PROPOSED HIGHWAY PROJECT

KTN HERRING COVE BRIDGE IMPROVEMENTS PROJECT NO. 0902043/SFHWY00072

GRADING, DRAINAGE, PAVING, PATHWAYS, SIGNING, STRIPING, ILLUMINATION, BRIDGE AND SIDE SLOPE STABILIZATION

Pad 6 Flat Bottom Ditch & Pipe "P-3"

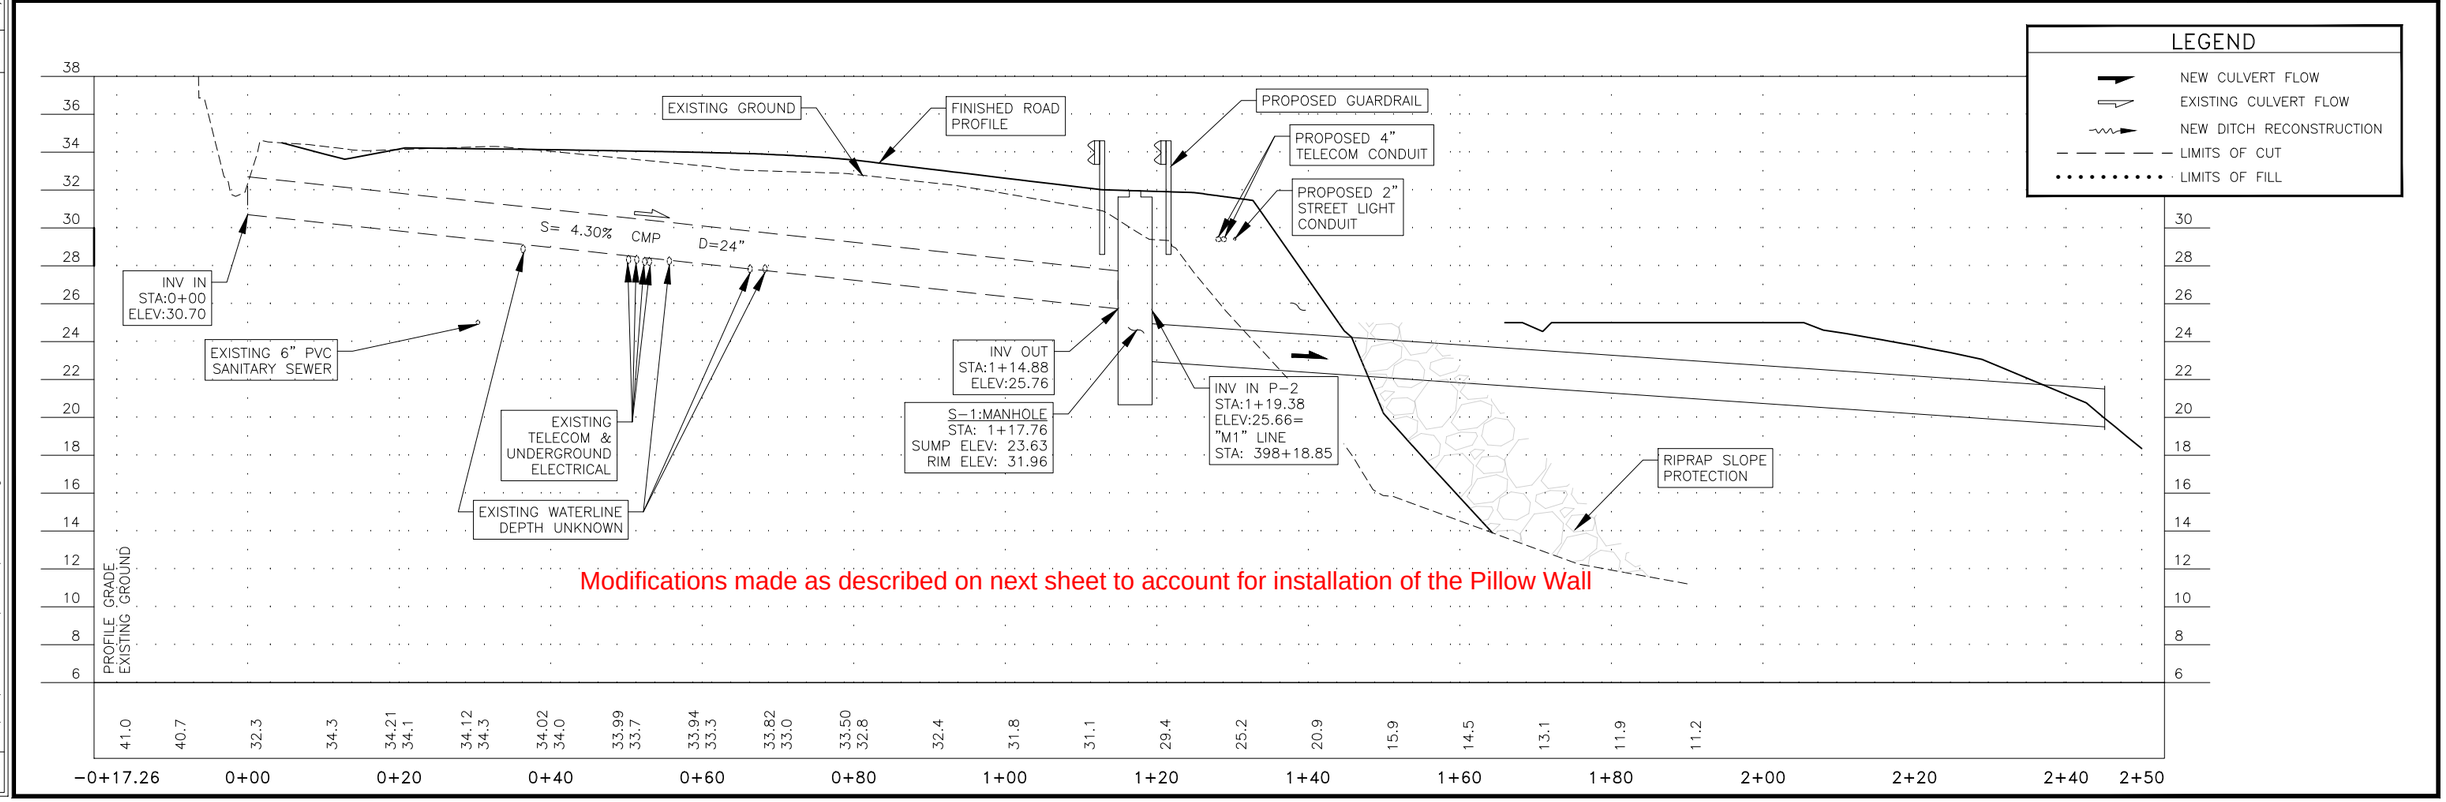
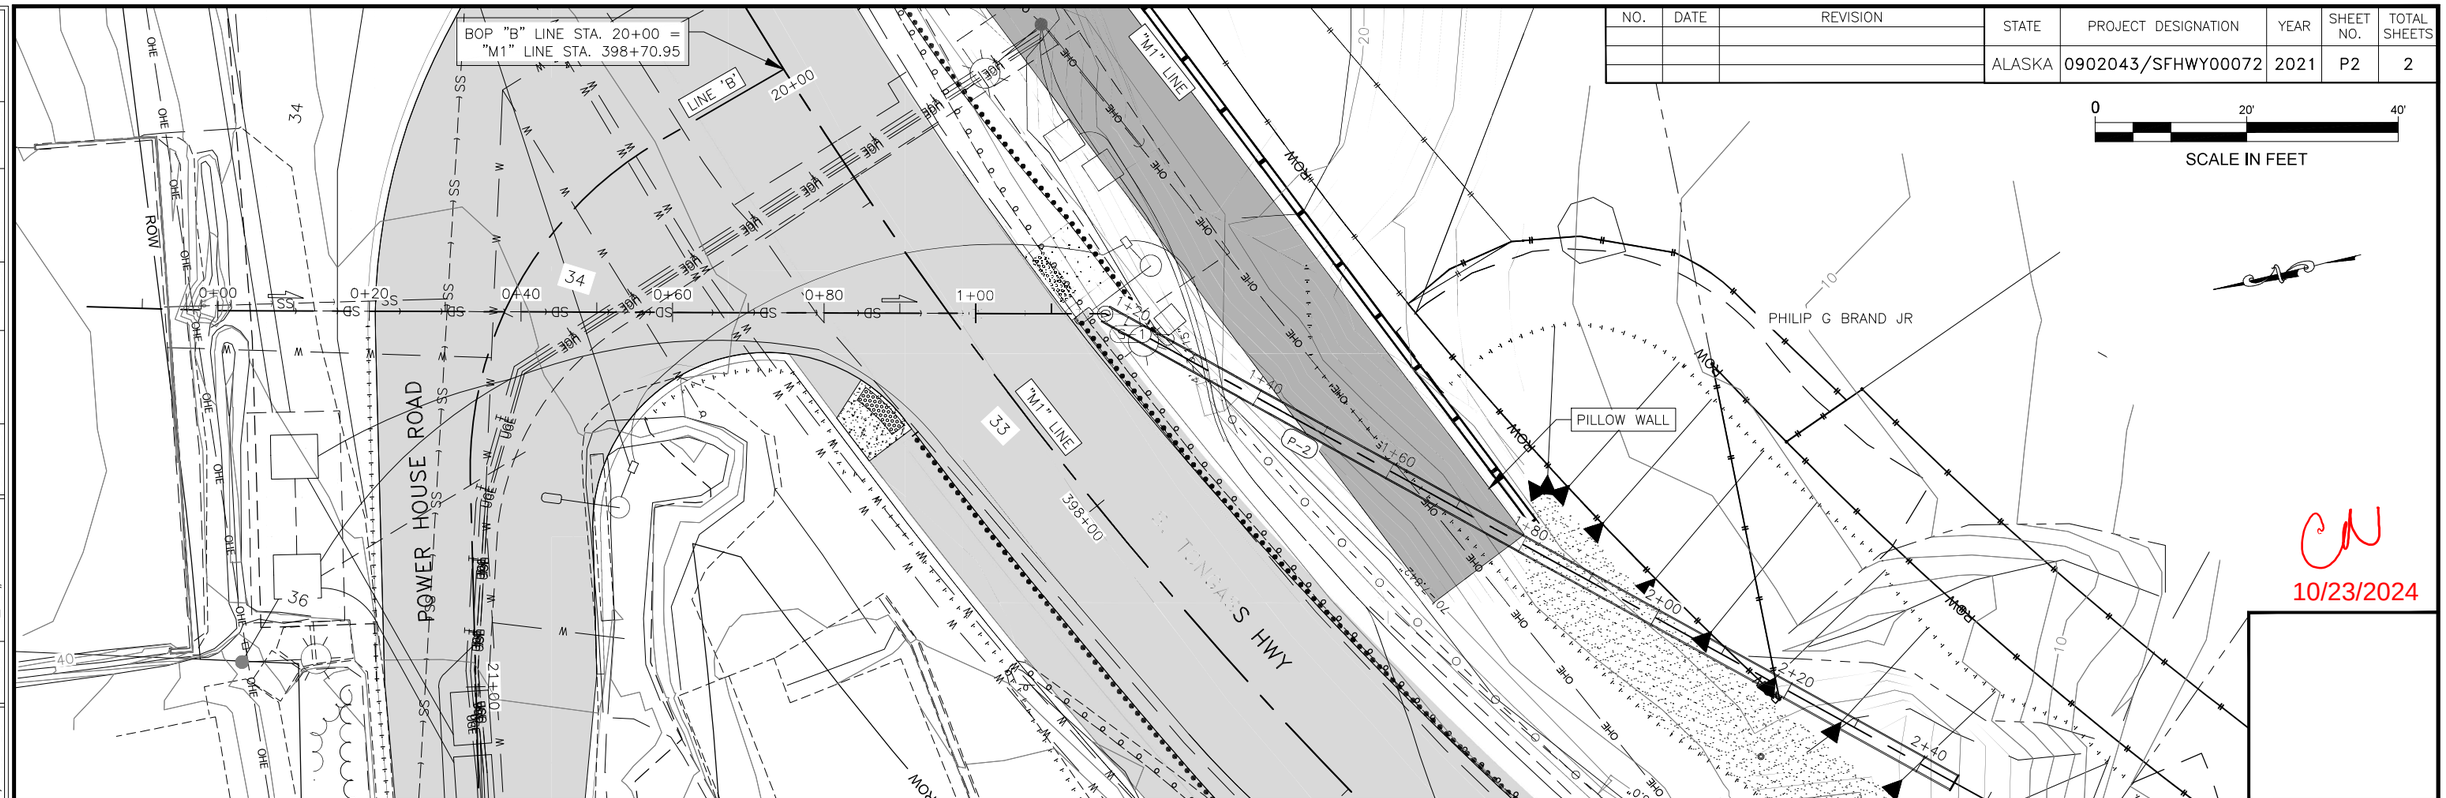
Modifications made as described on next sheet to account for installation of the Pillow Wall
